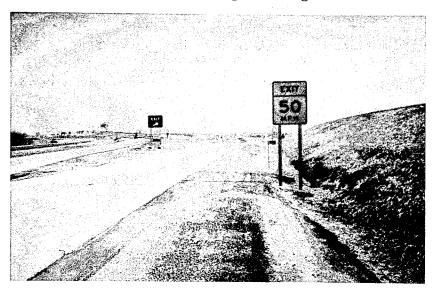
It is quite important this area be clear as far as visibility between the two roads is concerned. A driver coming down this roadway should be able to see traffic on this through lane as far back as possible in order to adjust his own speed and entry to the through lane.

To move on down to that gore, we find the exit sign here with rather heavy concrete footings sticking out of the ground.

And here we are—again the place here where the grading of the interchange probably could not be accommodated to make this a real safe place to run into, but it does not look like you have too good a chance of getting in there with those footings in the way as they are.
